CITY OF TAYLOR, TEXAS PLANNING AND ZONING COMMISSION MEETING

City Hall Council Chambers
400 Porter Street, Taylor, TX 76574
March 13, 2018 6:00 P.M.

PZ-2018-1081
410 West 7th Street
East Wilco 95, LLC
Amendment to Ordinance 2017-13

Staff reviewed the submission, and offers the following comments from the different Staff disciplines:

ATTACHMENT 4 - ORDINANCE EXHIBIT C
SITE PLAN (Sheet 2 of 3)

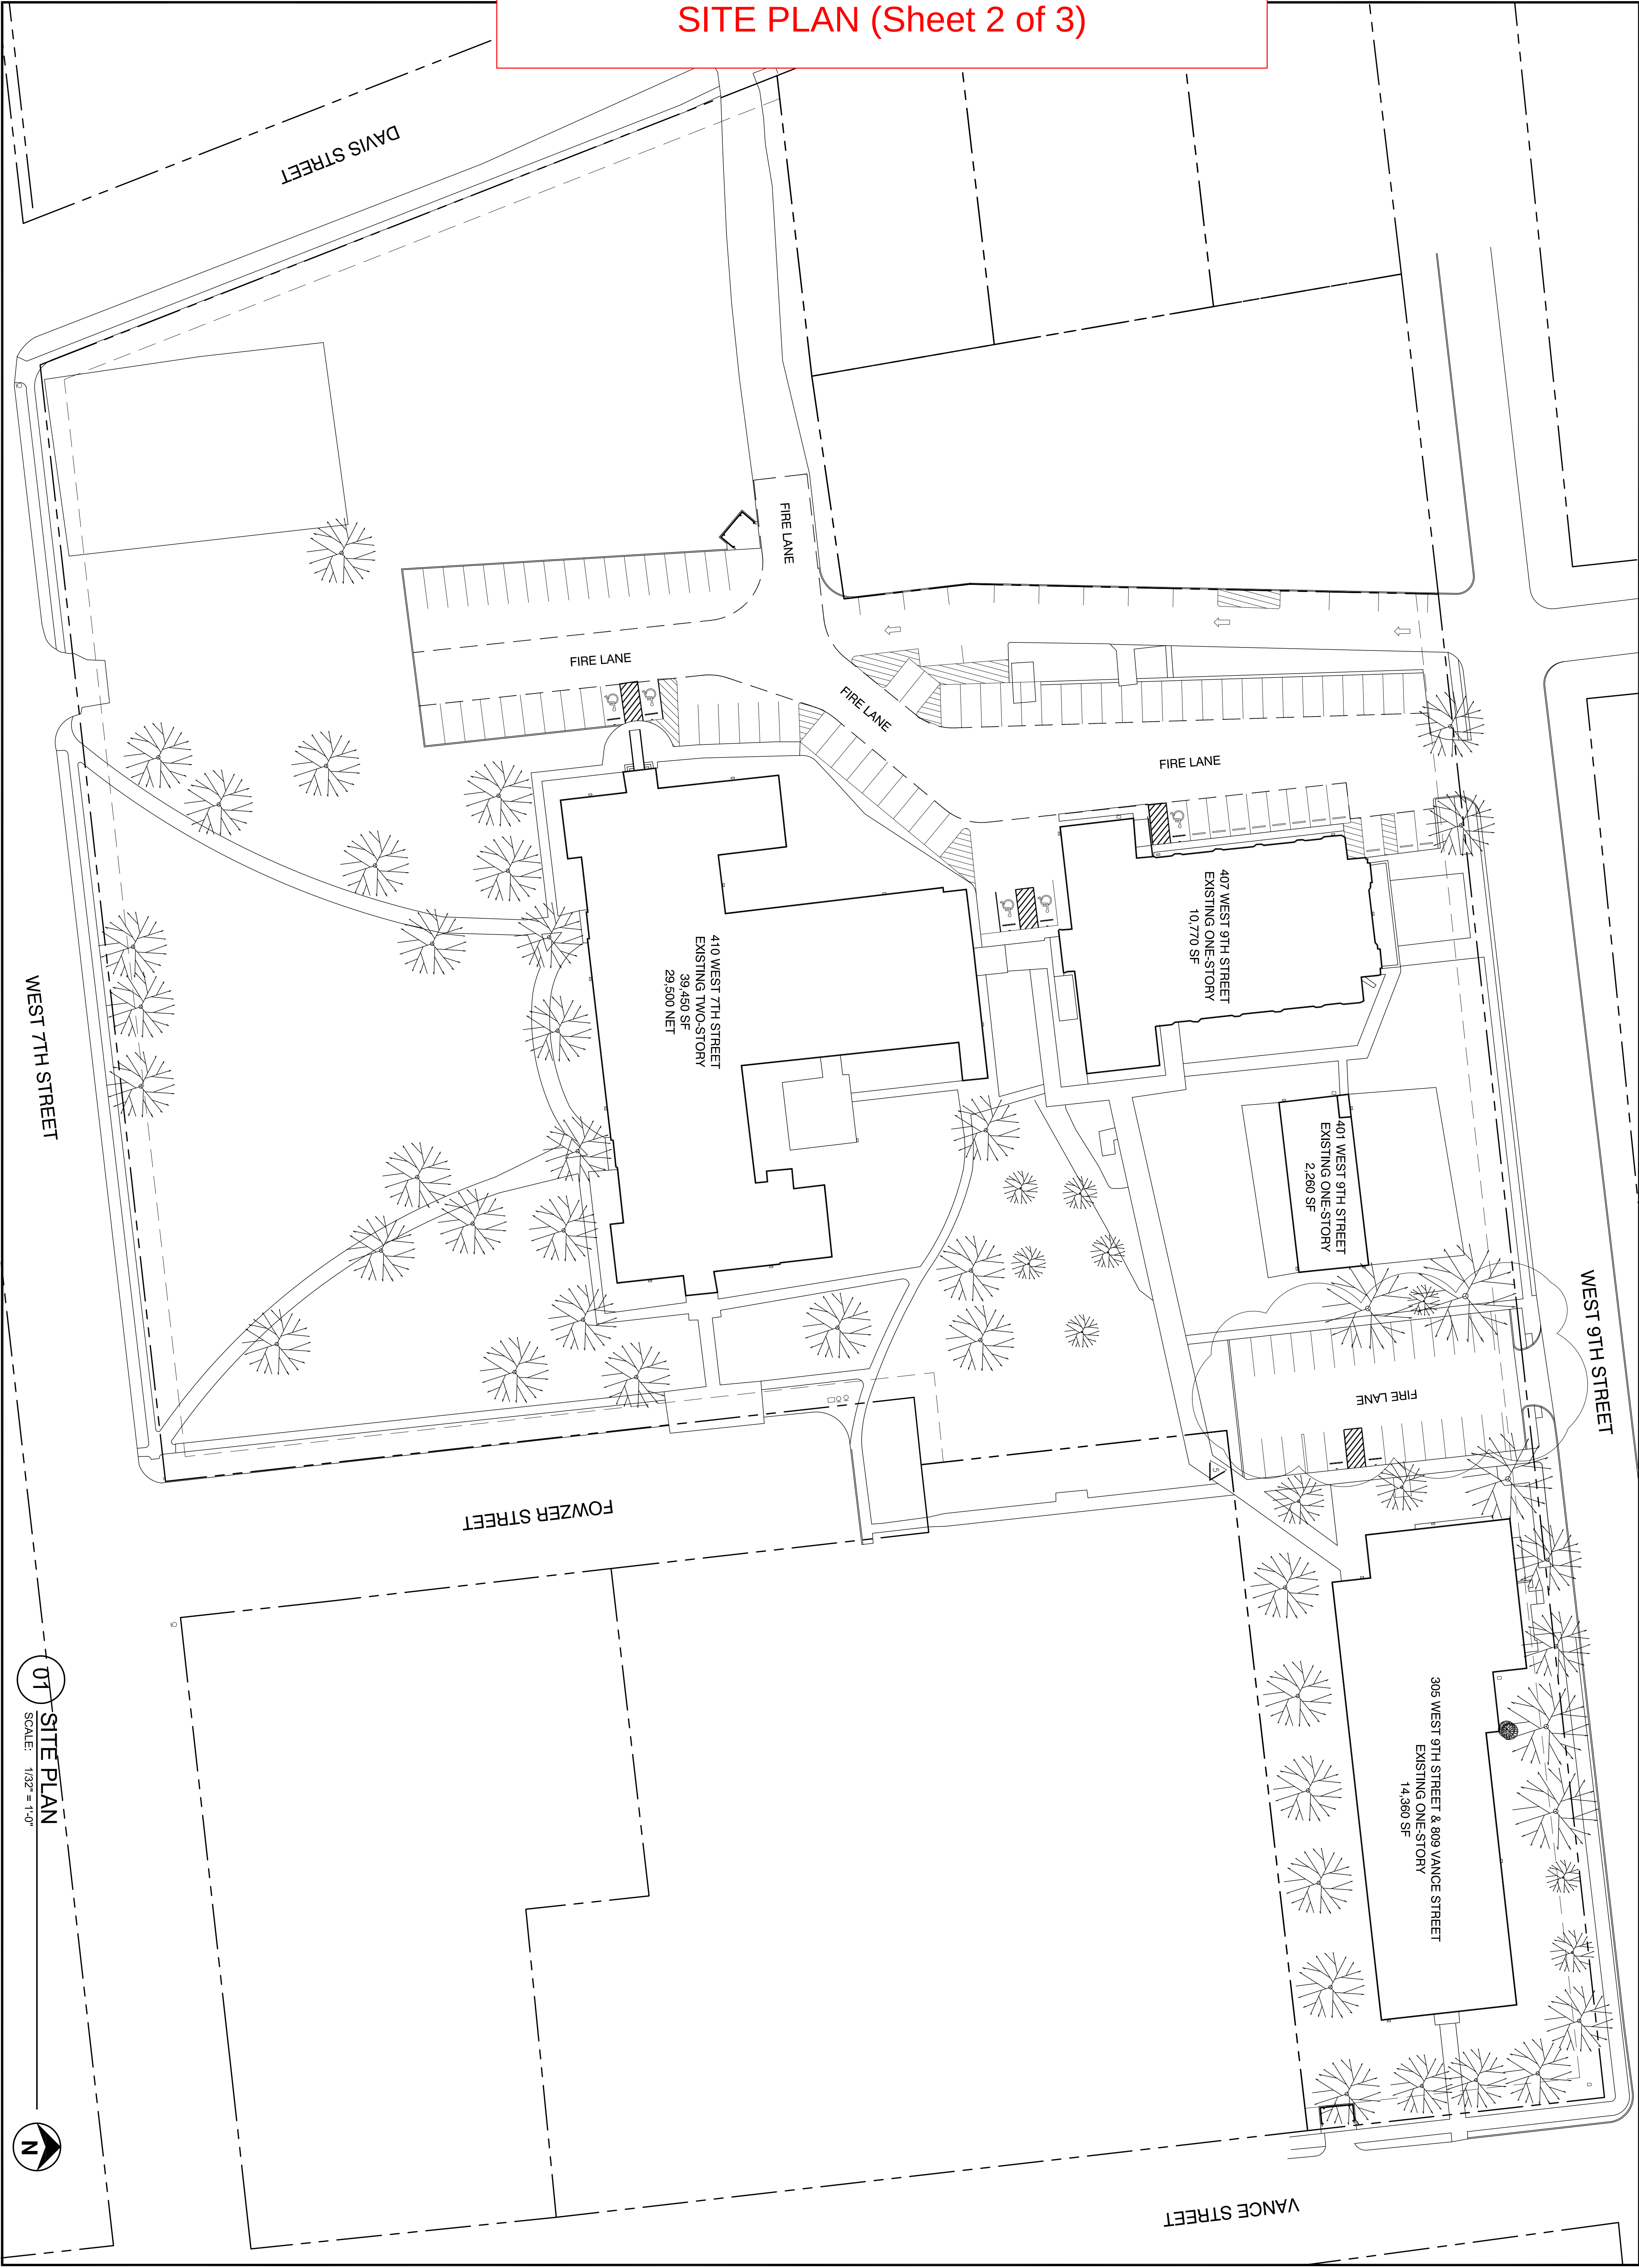
City Engineer – *Plans submitted show two different pavement sections.*

Detail #04 calls for 8" flexible base and 2" HMAC or 2 layers of tar and chip. If this detail is intended to be used the HMAC type and spec should be referenced and the optional "tar and chip" should be technically specified. The soil compaction in this detail should also reference technical specs such as method of compaction and density required.

Detail #05 shows the fire lane stripe block but also shows the Truegrid section the written report references. If this section is to be used, technical specs should [be] provided for the 6" crushed base and for the gradation of the #57 rock (to verify there will be void spaces). Also clarify if a geogrid liner or membrane is intended to be installed as the manufacturer references. Also, if this section is to be used, the proposed compacted soil beneath the Fire Lane stripe concrete will block drainage through the #57 rock. Suggest this be addressed.

**No structural concerns for Fire Lane for either proposed section.*
